MINUTES OF MEETING OF THE COMMISSION OF FINE ARTS,
HELD IN WASHINGTON, D. C., JANUARY 7, 1921.

The fourth meeting of the Commission of Fine Arts during the fiscal year 1921 was held in its office at 1729 New York Avenue, northwest, Washington, D. C., Friday, January 7, 1921.

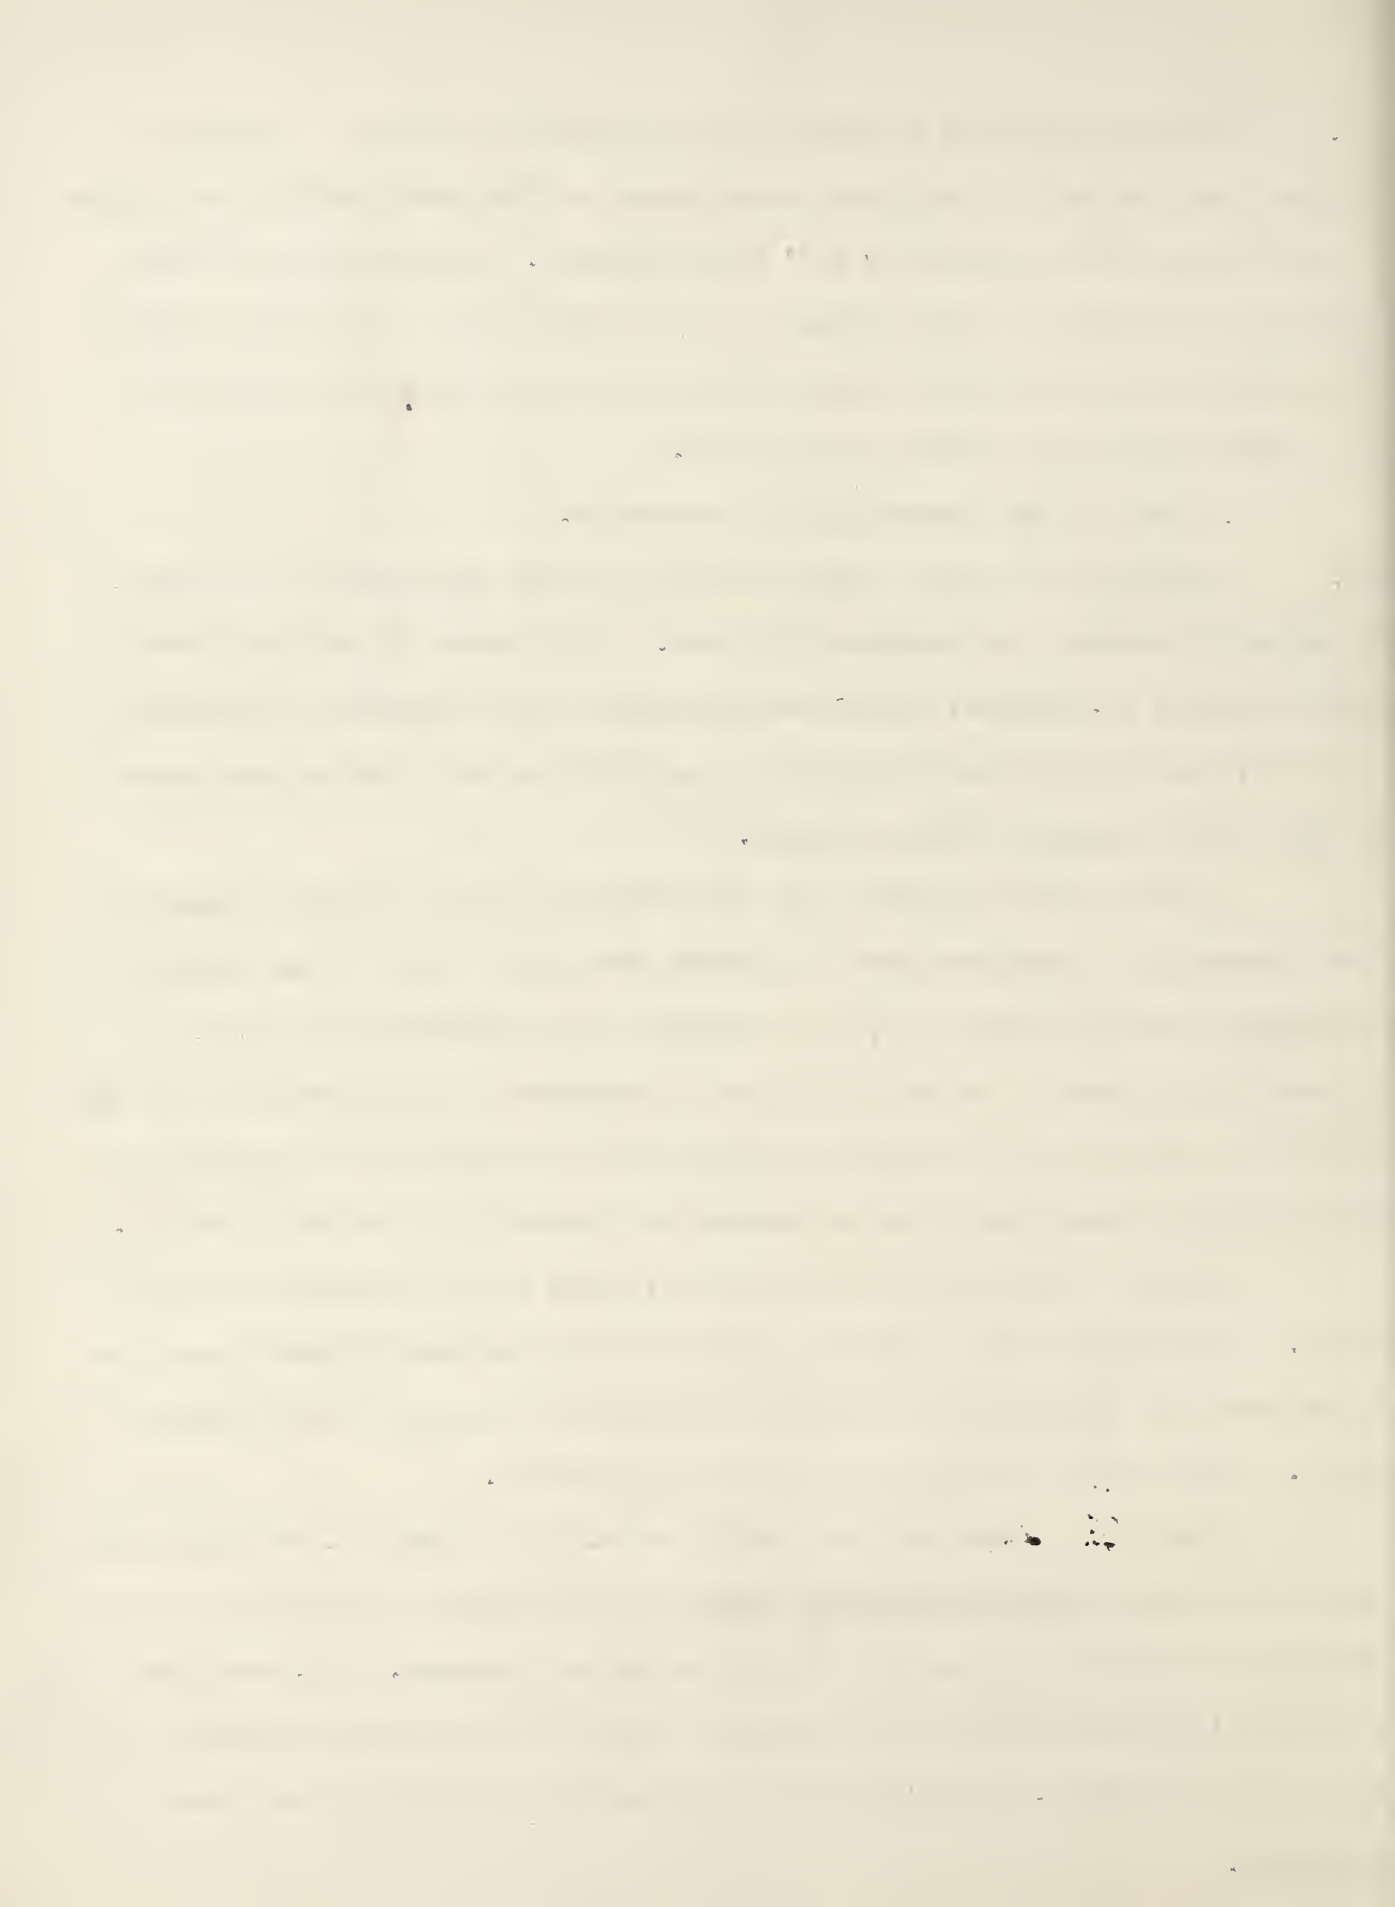
17. RESERVATION 276-A - GENERAL PLAN AND DETAIL OF COPING: The triangular area featured a large grass area planted to four American Elms and bordered along the edge of the area by a 7' brick sidewalk. Adjacent to this brick sidewalk was planned a clipped hedge 3' - 6" in width and 3' - 0" height, while the reservation was further set apart from the area belonging to the District by a cement coping of 6" reveal and 8" wide.

.This plan was approved by the Commission.
